Appendix H

Visual and Landscape

Our Ref: 71887/GMP/20070108_Response to Fraser Drive Residential Subdivision – Briefing Memo.doc

RE: RESPONSE TO FRASER DRIVE RESIDENTIAL SUBDIVISION – BRIEFING MEMO

Fraser Drive Streetscape / Boundary Fence - Typical Elevation

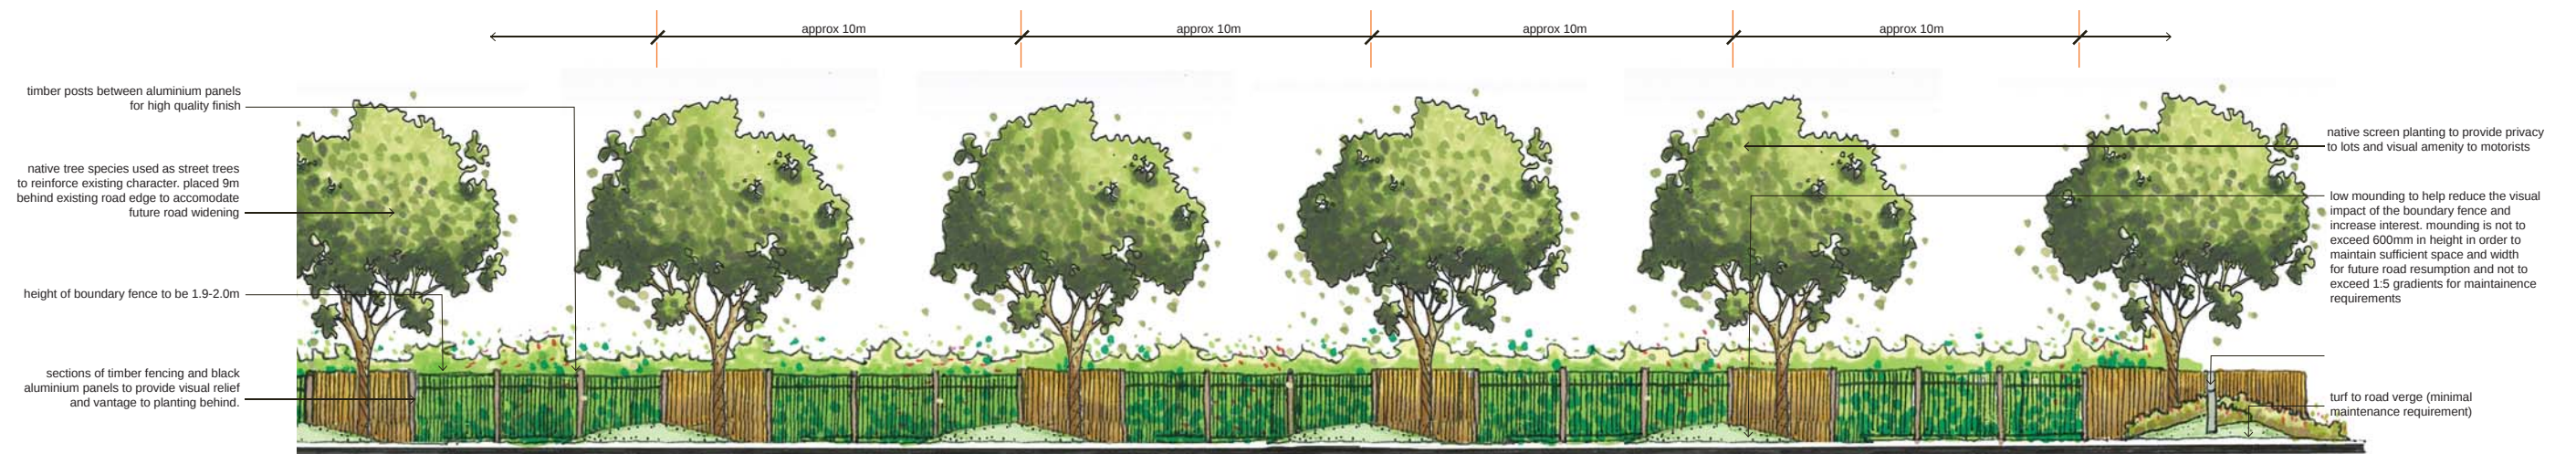
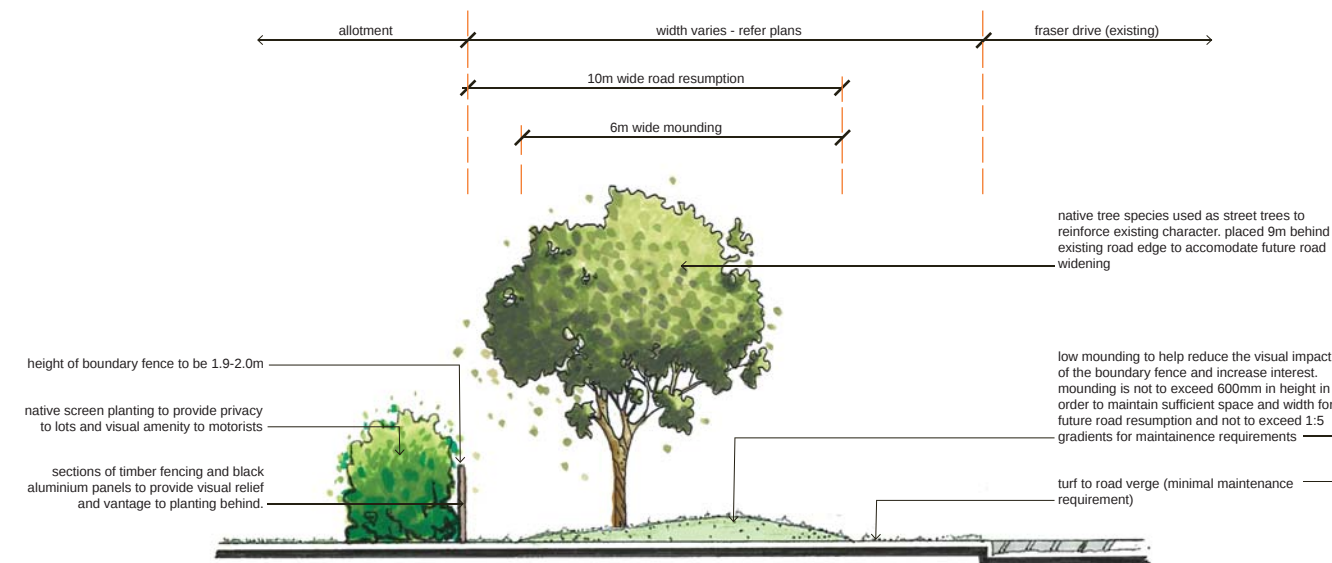
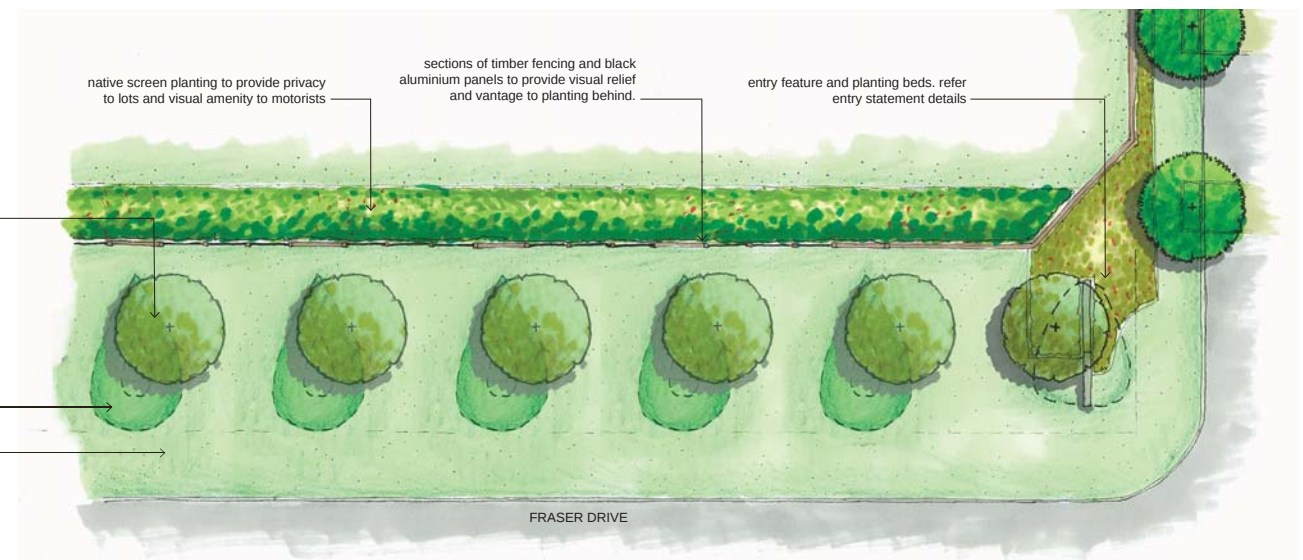
The applicant is requested to provide a cross section of the Fraser Drive frontage depicting the levels of dwellings, fence, mounding I landscaping, proposed height of fill and the ground level in the adjoining road reserve.

The Visual Impact Assessment does not make any assessment of the proposed acoustic barrier that will be constructed between Fraser Drive and the eastern boundary of the proposed subdivision. An assessment of this structure should be undertaken.

It is difficult at this stage to provide sections without further civil, structural and acoustic information not yet developed due to the status of the project. There is a large amount of detailed (construction) information required in order to illustrate how sections would look based on proposed 'cut and fill' levels and building pad heights.

Required acoustic information which details appropriate setbacks for homes from the noise wall and how high those dwellings can be to still be acoustically appropriate for residential use is not yet available.

This information is not yet available to correctly show how the section would look, however typically, a landscape treatment would be proposed to soften the visual impact of the noise wall from inside the lot. Otherwise, the proposed noise wall concept details and character images on sheet 71887_D_CP_06 (01) details the noise wall (fence) treatment, the mounding and indicative landscape treatment.

Please note that the assessment of the acoustic barrier has been addressed within the Landscape Concept Plan Report on sheet 71887_D_CP_06 (01).

The assessment and proposed design solution complies with 'Cardno – Proposed Development Fraser Drive - South Tweed 'Acoustic Assessment (20 December 2006- Job No. 7214/29)'.
'

Further to this, the proposal was developed under the guideline document '*RTA - Noise Wall Design Guideline - Design Guidelines to Improve the appearance of noise walls in NSW*'.

Although not directly stated in the visual assessment report, the proposed vegetation along the acoustic barrier would provide (in addition to the existing vegetation) and increase the visual absorption capacity and therefore minimizing the acoustic barriers impact upon the development and the surrounding streetscape.
